X-TYPE

XT501-S934

TECHNICAL BULLETIN

Change In Specification –
Reprogram RCM –
Service Action S934

ILLUSTRATION 1

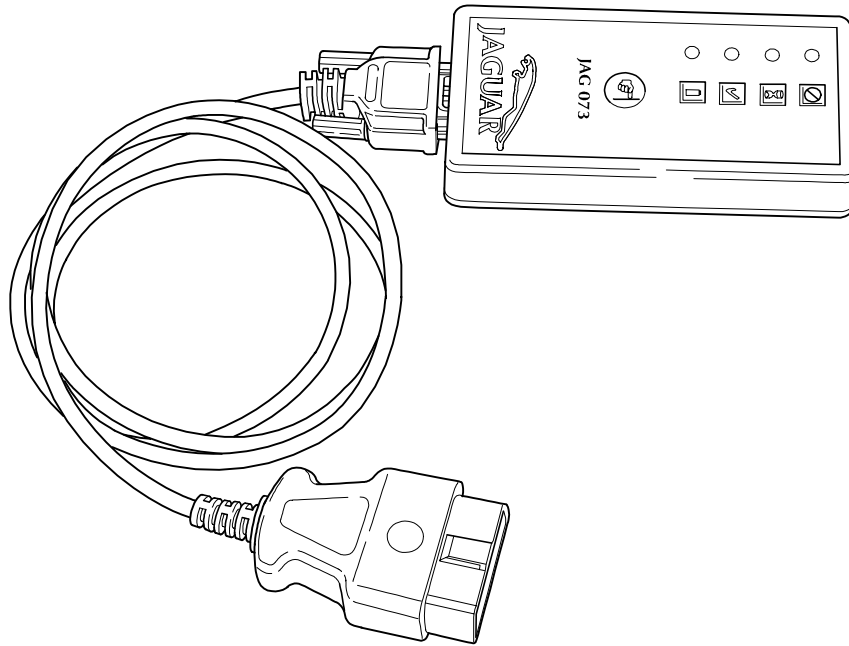
5. Connect special tool JAG 073 (Illustration 1) to vehicle diagnostic link connector.

Note: Special tool JAG 073 'power on' Light Emitting Diode (LED) (yellow 4th from top) will remain on continuously while connected.
